ADDENDUM NO. 002

RE: Water System Capital Improvements – Phase II
For Town of Bluefield
T&L Project No. 16176

DATE: June 8, 2023

C103

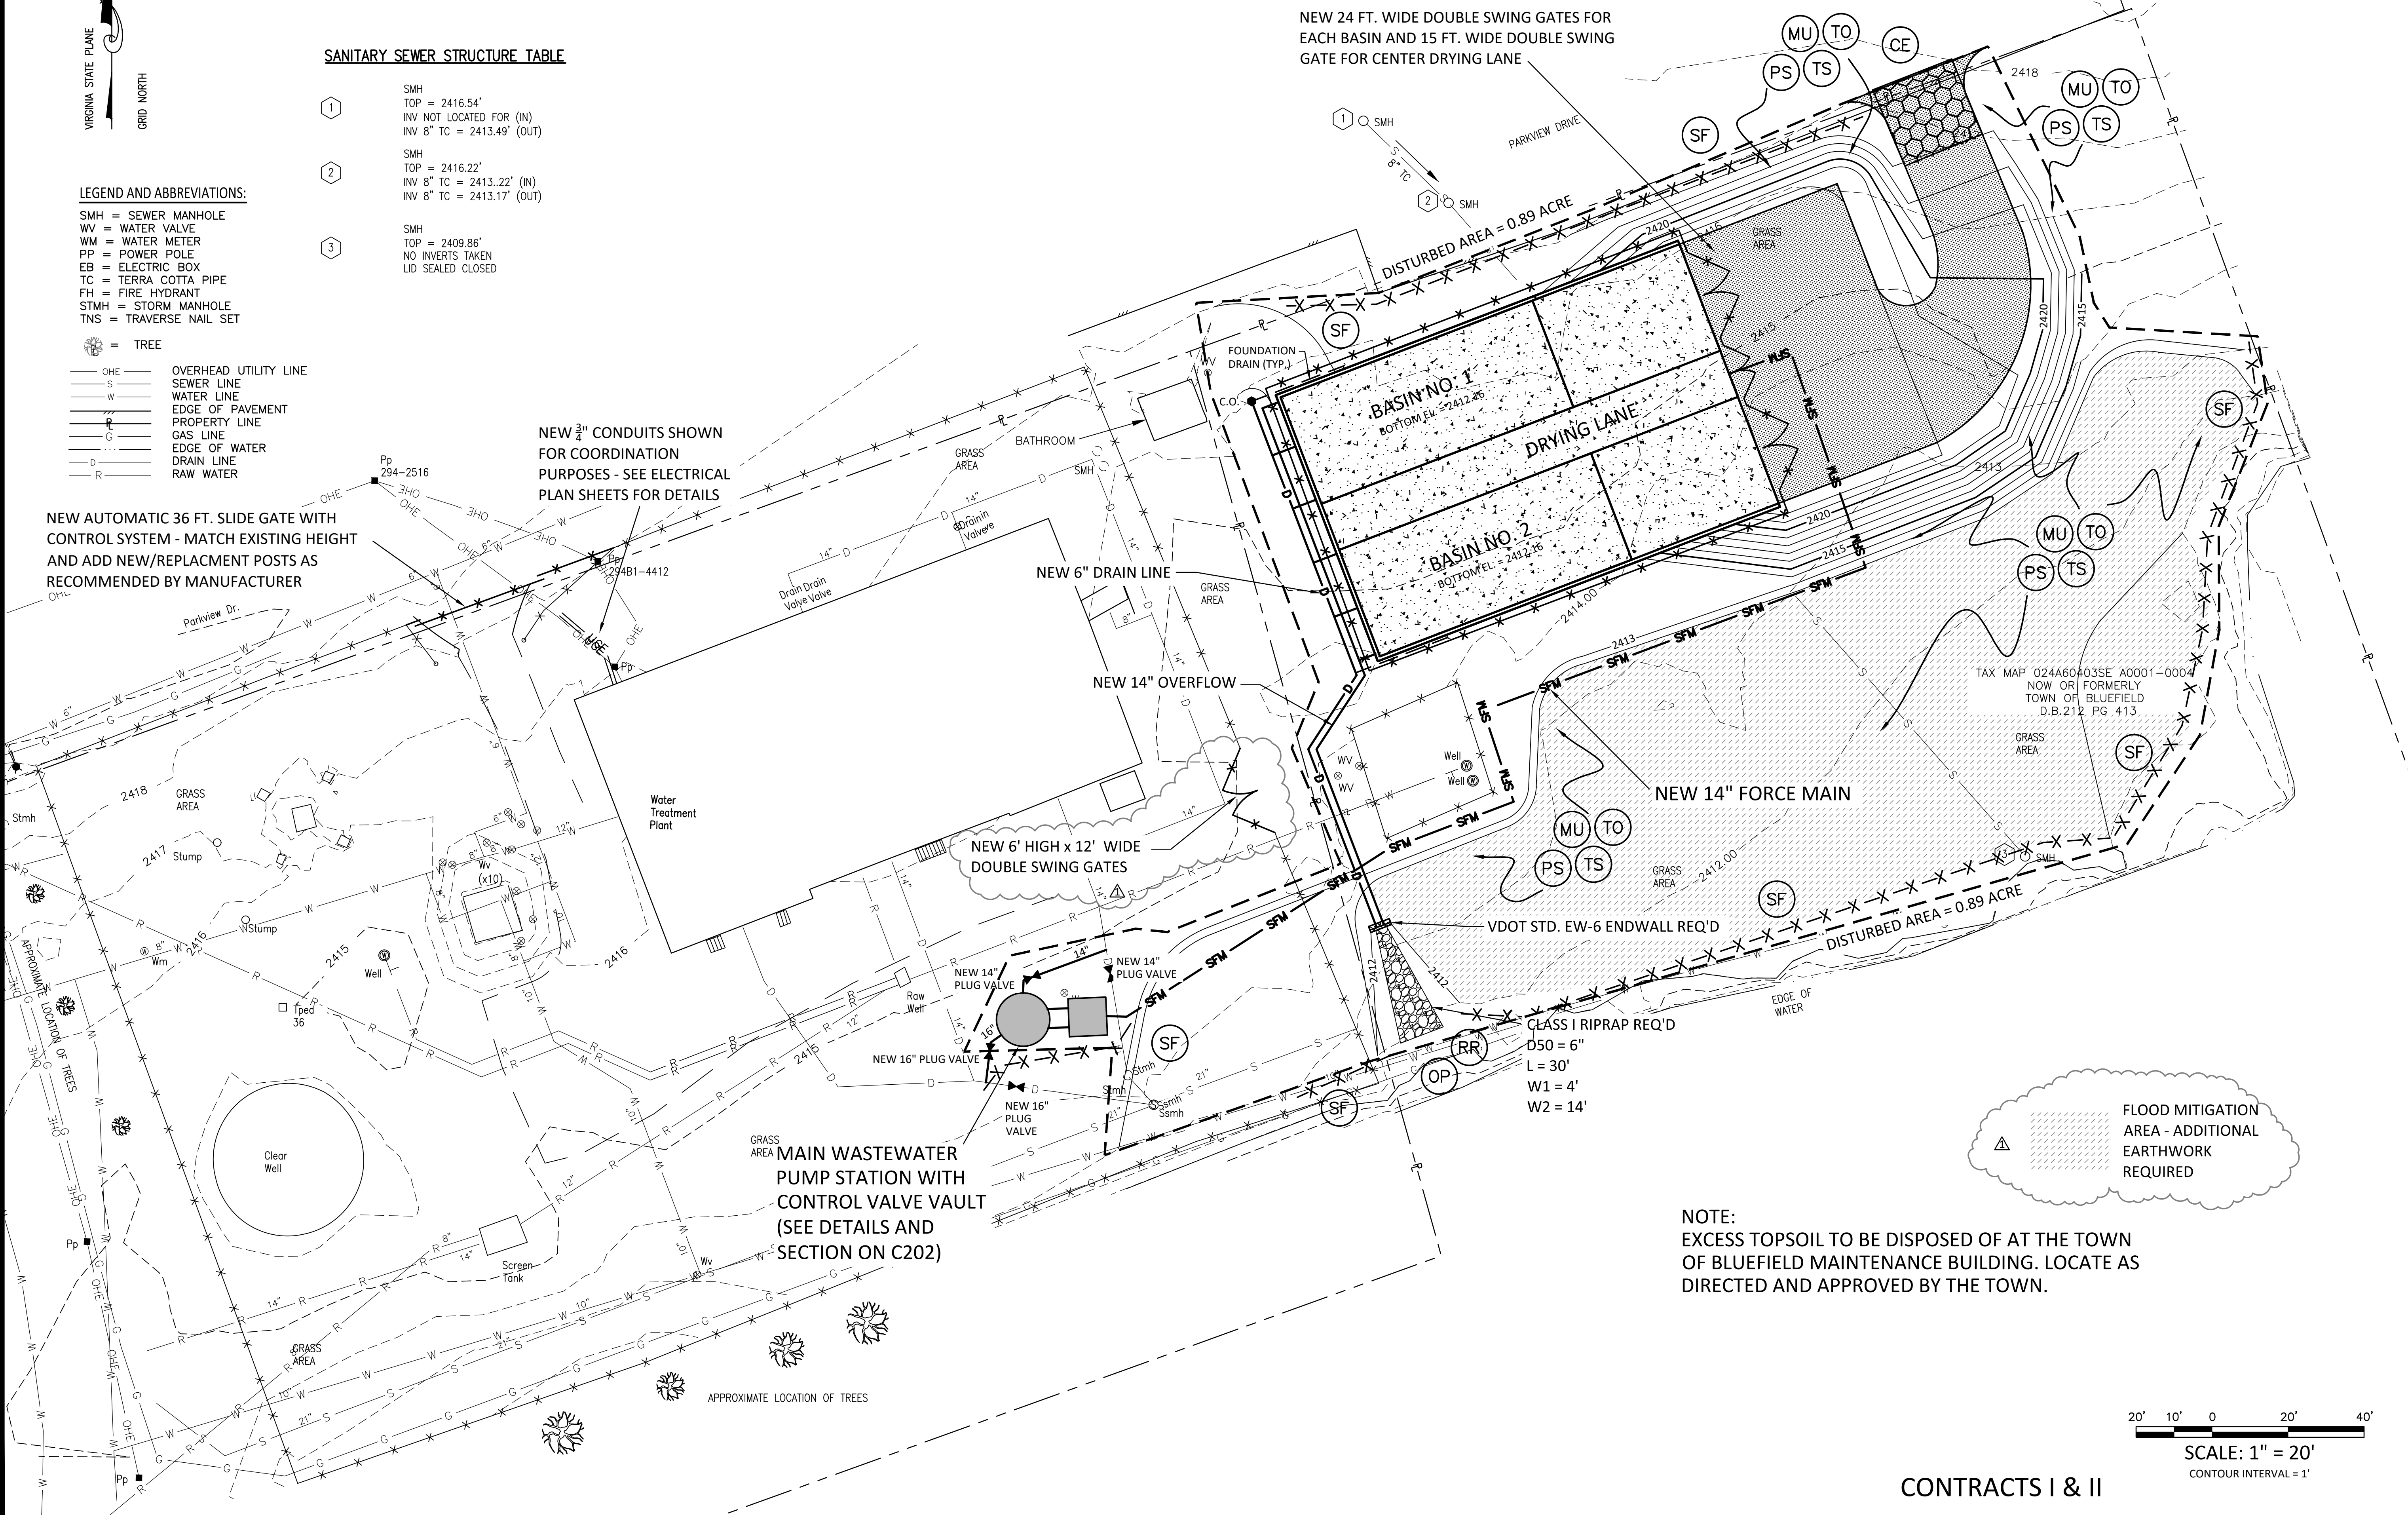
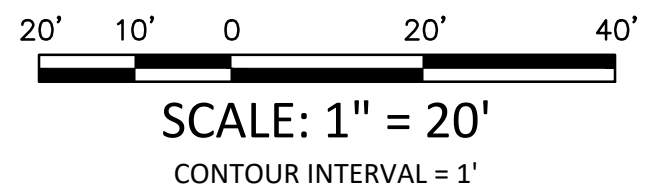
1. Drawing C103 has been revised to add new 12' wide double swing gates to the existing fencing between the park and the water treatment plan and add hatching to delineate the area adjacent to the basins where additional earthwork shall be performed to satisfy flood mitigation requirements. The revised drawing is enclosed.
2. Drawing C201 has been revised to add clarification for the ornamental aluminum fencing. The revised drawing is enclosed.
3. Drawing C207 has been revised to clarify the motor requirements for the Raw Water Pump. The revised drawing is enclosed.
4. Drawing E101 has been revised to shift text for visibility. The revised drawing is enclosed.
5. Drawings E102 and E103:
 - a. Additional information has been provided in regards to startup requirements.
 - b. Each ATS withstand requirement value based off of given fault current has been corrected.

NEW 6' HIGH x 12' WIDE DOUBLE SWING GATES
